3. **CASE 23.072, 92 WILLIAMS STREET, Caleb Roffee House, 1824 (COLLEGE HILL)**

Proposal: The scope of work proposed consists of Minor Alterations and includes:

Arrow indicates 92 Williams Street.

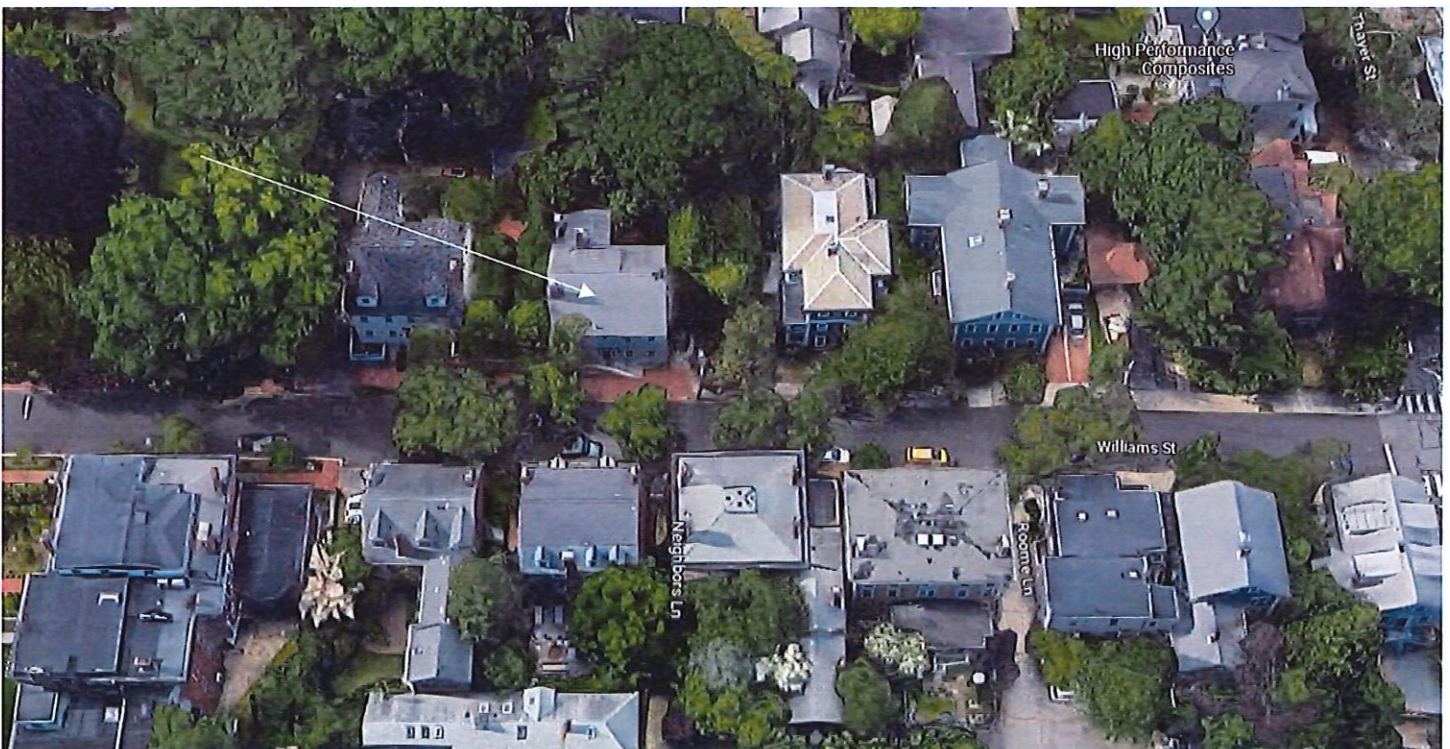
- Due to the narrowness of Williams Street, the height of the subject property and that the subject property and adjoining properties are built to the front lot line, it is Staff's opinion that the array as proposed will not be visible from the public rights-of-way;

1 ROOF PLAN WITH MODULES

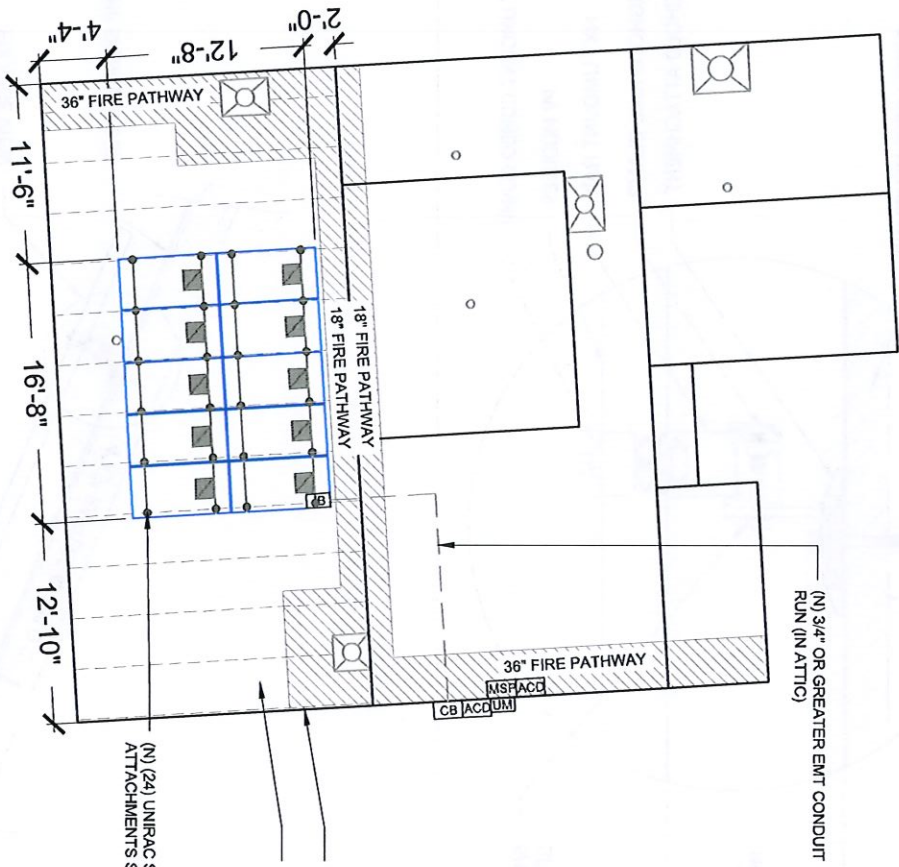
- Staff recommends the three panels at the western side be moved as much as possible to the east to decrease possible visibility;
- The modifications as proposed meets Minor Alterations: Solar Energy Systems Guidelines, Section 2, in the following manner: Panel layout shall be sympathetic or appropriate to design and scale of building. Rectangular configurations are preferred, with ample setback from edge of roof, dormers, chimneys, etc. (2.A); Panels shall be installed parallel to the existing roof slope and matched as closely as possible to the roof plane (2.B); Panels shall be installed without destroying or replacing original or historic materials or significantly compromising or altering the building's structural integrity (2.C); Panels shall be compatible in color to existing roofing insofar as possible (2.D); Installation of panels shall be as inconspicuous as possible when viewed from public right-of-way (2.E); Installation shall be reversible. Panels shall be removed when no longer viable or functioning and roofing restored to pre-existing conditions (2.F); and,
